STAFF REPORT AND RECOMMENDATION TO THE DESIGN COMMISSION

CASE FILE: LU 16-289838 DZ
 PC # 16-262911
Ladd's Addition Flats

The applicants request Design Review for a new four-story, 45'-0" tall mixed-use retail and residential building in the Central Eastside Subdistrict of the Central City Plan District. The proposal includes 1,800 square feet of retail space at the ground floor along SE 11th Ave and opening onto a courtyard that extends into the site from the street. Four residential dwelling units face east on the ground floor, and an additional 30 dwelling units are proposed on the upper three stories. The exterior of the building is proposed to be clad primarily in darkly-stained tongue-and-groove cedar siding. No parking or loading spaces are required.

WEST ELEVATION

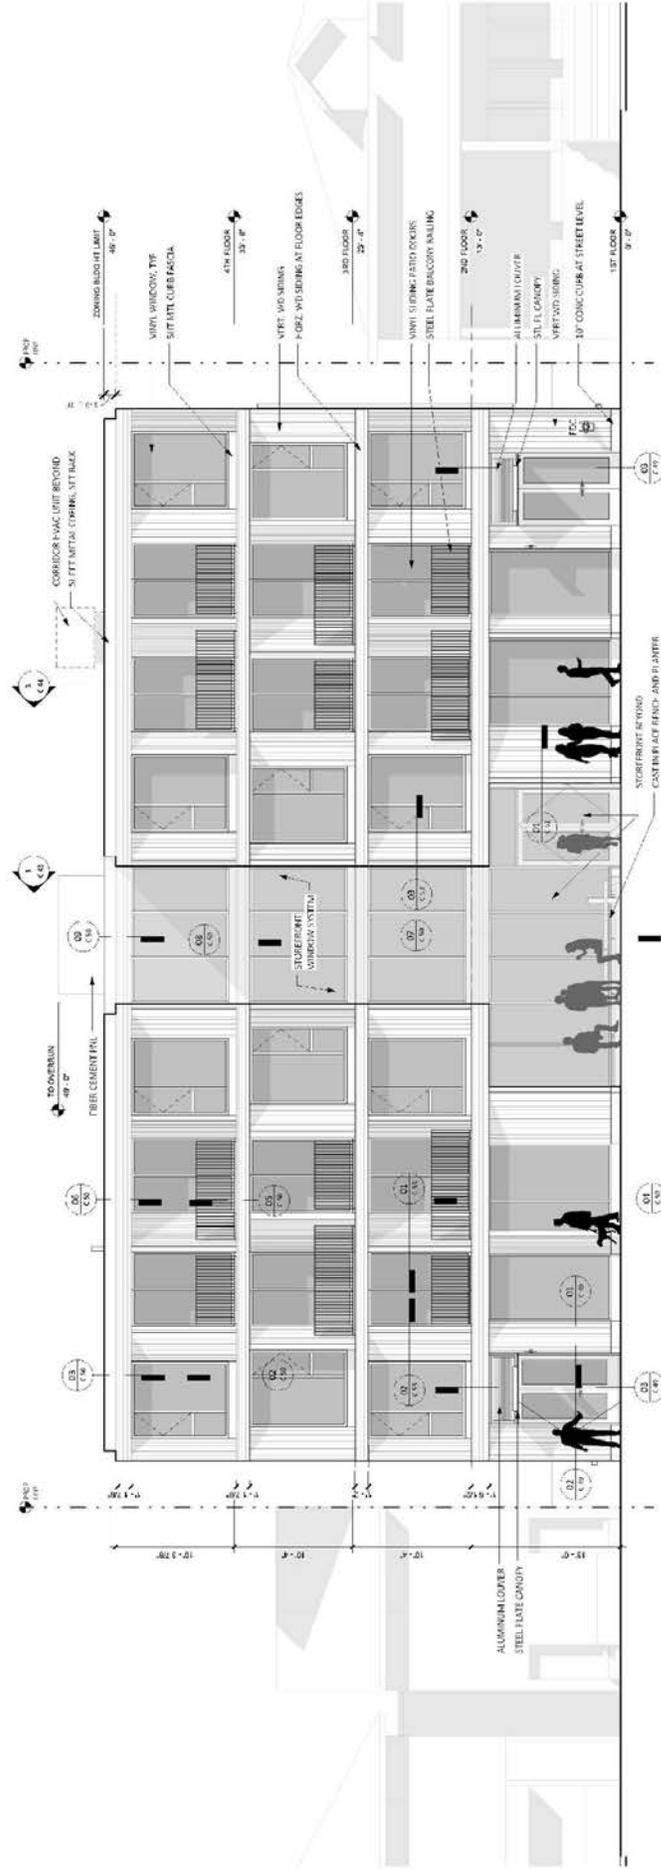
Findings: The proposed building incorporates large storefront and residential windows and sliding doors and balconies on the west elevation, which allow views towards the Central Eastside, other parts of the Central City, and, potentially, towards the Willamette River and West Hills. The large storefront windows also allow views from the sidewalk and the courtyard into the retail spaces at the ground level. A large bank of storefront windows at the east end of the courtyard at the ground floor and upper stories provide views out from the public spaces in the residential portion of the building towards the courtyard, sidewalk, and Central Eastside.

EAST ELEVATION

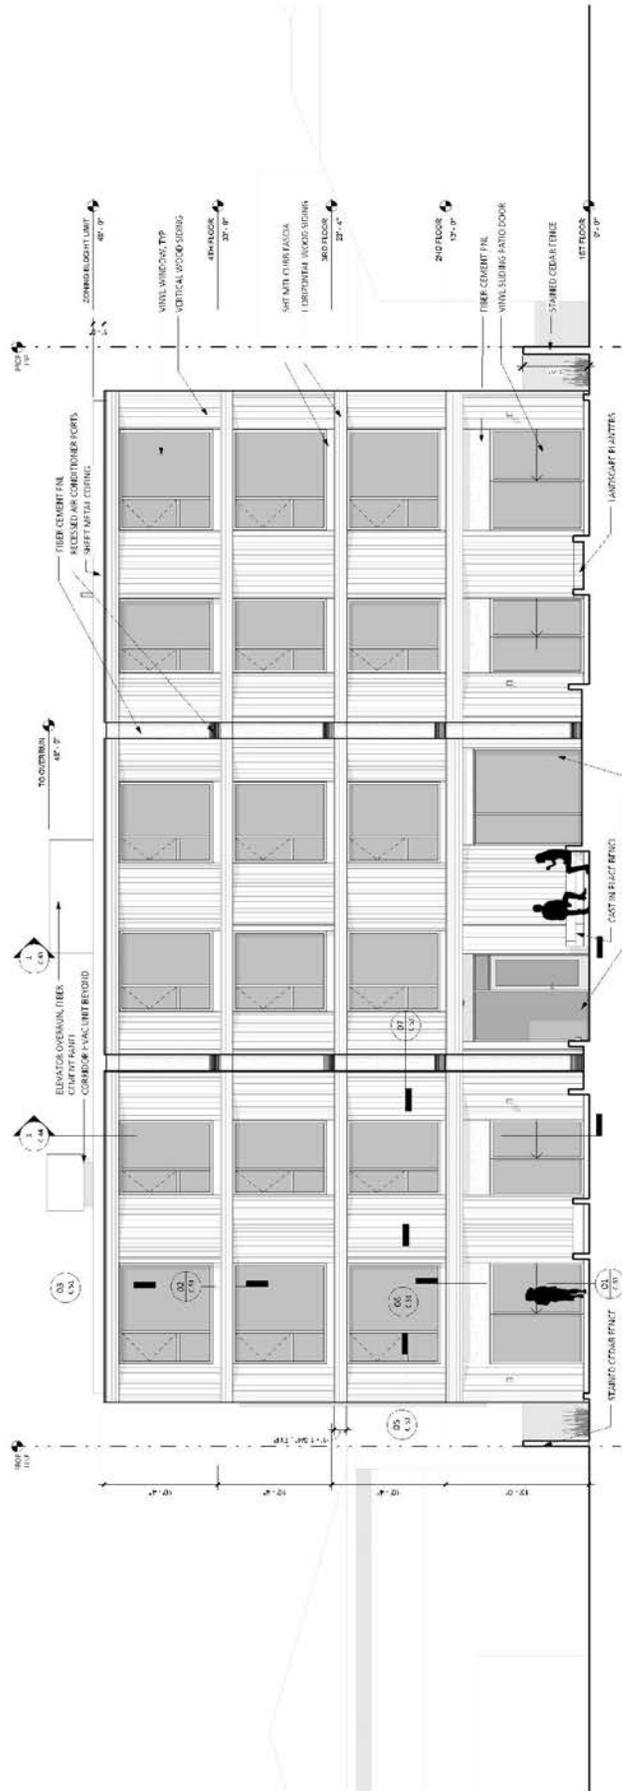
The east façade has additional articulation in the form of vertical recesses which divide the 90'-wide elevation into three bays. These recesses

reference both the massing of the building on the west elevation and the smaller-scale massing of residential buildings to the east.

Windows that are slightly narrower than those on the west façade are utilized on the east façade, and these provide views to the common residential outdoor space on the east side of the property and towards Ladd’s Addition. A fence around the east side of the property, along with landscaping, helps to preserve privacy of adjacent residential properties and also limits views from those properties back into the site.

SOUTH ELEVATION

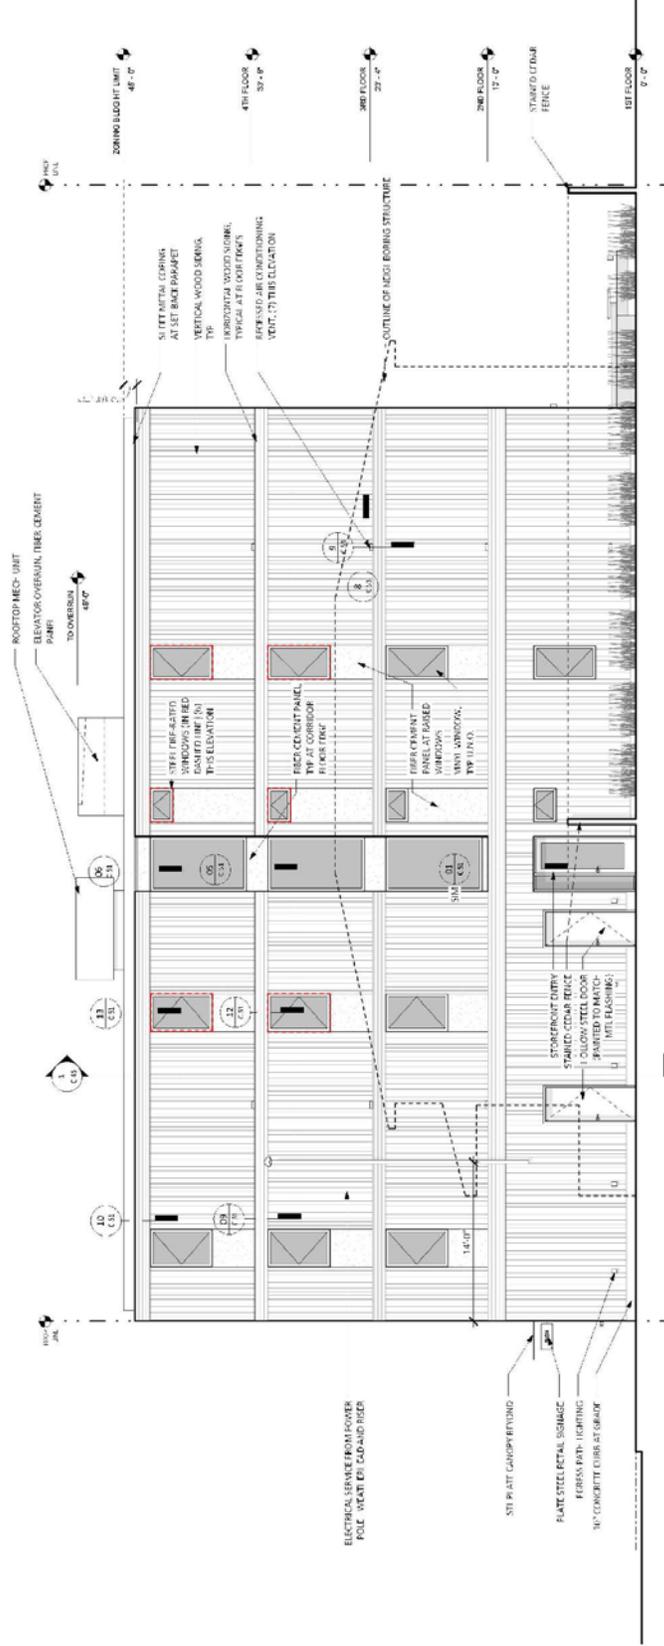
The storefront design diverges, somewhat, on the north and south courtyard elevations. A sliding window system is employed at the north courtyard elevation, and this system incorporates similar design elements as the storefront system. Vertical sashes are, by necessity, more prominent on this sliding storefront system, though the overall system integrates well with the overall design of the ground floor. The south storefront system utilizes the same storefront windows employed on the west elevation; however, the storefront system is not shown on the same 10” curb, but rather is shown extending to grade. Though a somewhat minor detail, this may increase the potential for damage to the storefront system; and though the lack of curb here relates to the sliding storefront system across the courtyard—which has no curb to allow for barrier-free ingress and egress—the storefront system could be better integrated with the overall design concept with a 10” curb.

With the condition of approval that the storefront system in the south courtyard elevation shall sit on a 10” concrete curb that matches the curb used on other storefront details; and,
